MEMORANDUM TO: Mayor and City Council
Planning Commission

FROM: Rob Robinson, Long Range Planning Manager

SUBJECT: Staff Analysis: Application Z-9444-2022

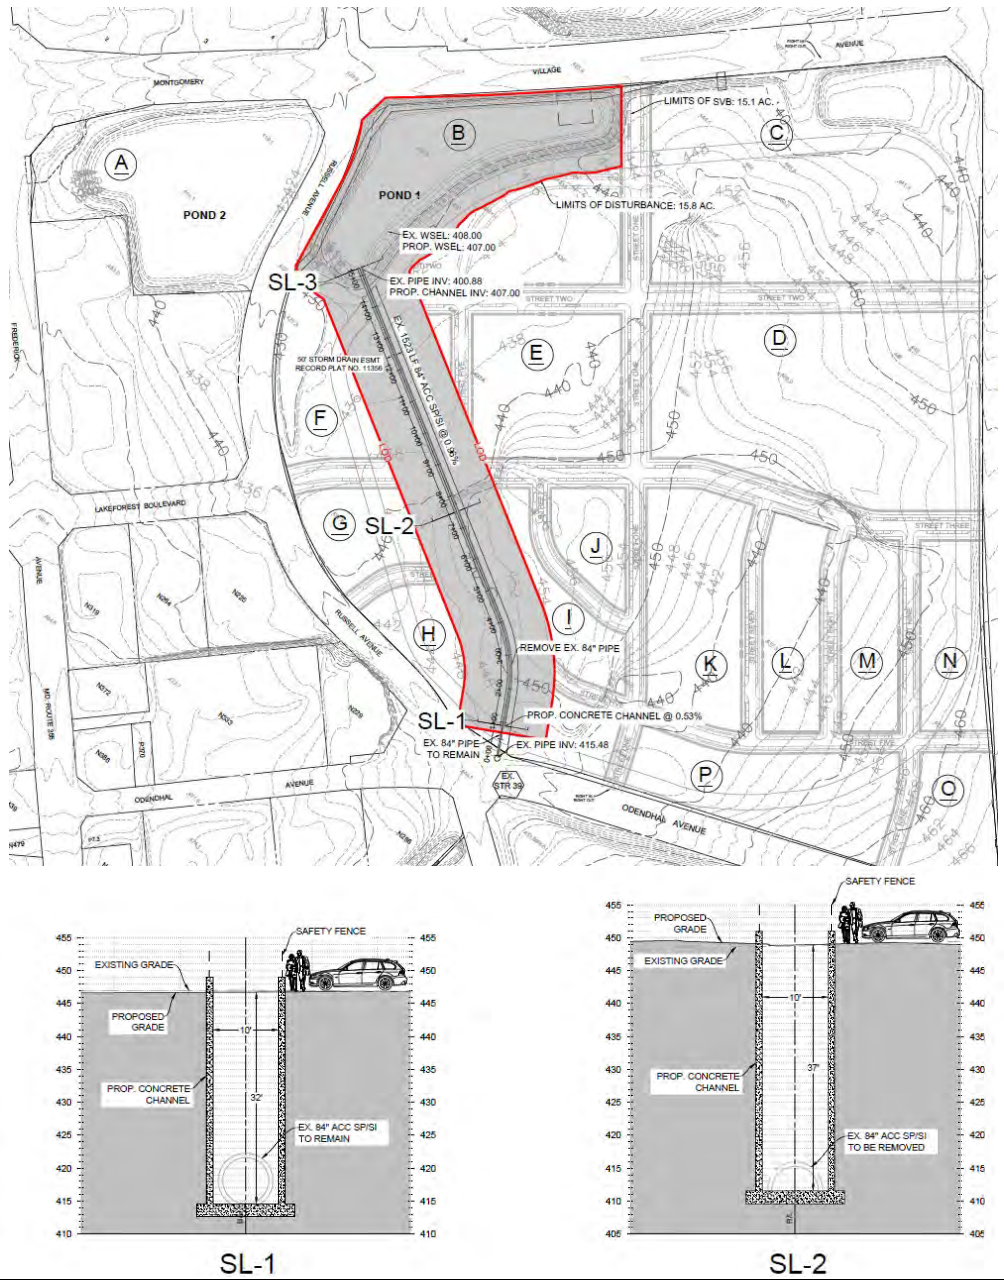
Exhibit 1 shows the information necessary to just 'daylight' the storm drain pipe, while maintaining a concrete channel to convey water. This leaves the pipe/drainage way in the same location with RED outlining the limits of disturbance (LOD). The seven-foot (7') diameter pipe entering the site, below Odendhal Road is approximately 30' deep. A concrete channel installed to replace the pipe would be 10' wide and over 30' deep particularly in the middle of the site where the grade is higher. A width of 10' wide would convey water and flood events to Pond 1. This alternate form of water conveyance within the same general area, aside from being an aesthetic liability, would affect Blocks F, G, H, and I.

Staff concurs that this scenario is a non-starter. It would be nothing more than a 10' wide, 30' deep reinforced concrete drainage ditch with no aesthetic or amenity value as hoped for in the public comments and would only negatively impact the proposed design.

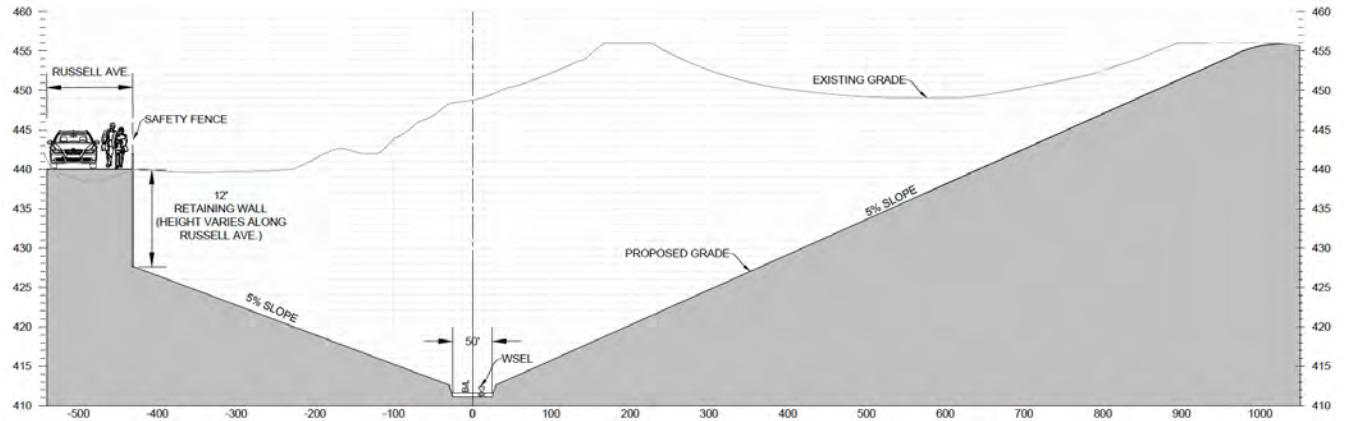
Exhibit 2 concerns a scenario that reflects a true daylighted stream as advocated for. Understanding that one foot (1') of flood water can float a car, Exhibit 2 shows a 50' wide base flow channel that will be between 1.5 to 2 feet deep. The RED is the LOD and the YELLOW is the new required stream valley buffer. The floodplain and 25' building restriction line (BRL) is not determined. To accomplish daylighting a pipe 30' below grade, approximately 37 acres of the developable 75 will be needed to lower the site, provide appropriate side slopes, stream valley buffer, floodplain and floodplain BRLs, retaining walls, etc. to make this work. This scenario would open the possibility of MDE and ACOE review and standards for waterways and floodplains. Walls of varying height will be needed to hold up Russel Ave., Odendhal Ave. and the proposed Street 1 on the Sketch Plan. To create the "stream valley" Blocks B, E, F, G, H, I and J will be eliminated. The east west roads would not connect. In particular, the Master Plan recommended Lakeforest Blvd. to Contour Rd. connection would not occur. Block F with the Transit Station would need to be relocated, or not included. Pond 1 and Block B with the entertainment district would also need to be reevaluated or moved since the grading, storage and flood elevations for Pond 1 will need to be changed.

Staff agrees that while this scenario would create a dramatic stream valley park, it would also render the Project economically infeasible not just from the cost side, but from the reduced development capacity perspective. The site work needed would greatly limit any developer's ability to realize the Master Plan and its recommendations. Staff does not support daylighting the storm pipe and is concerned that any such requirement will in fact curtail Master Plan envisioned redevelopment and result in continued C-2 Zoning and vested operations.
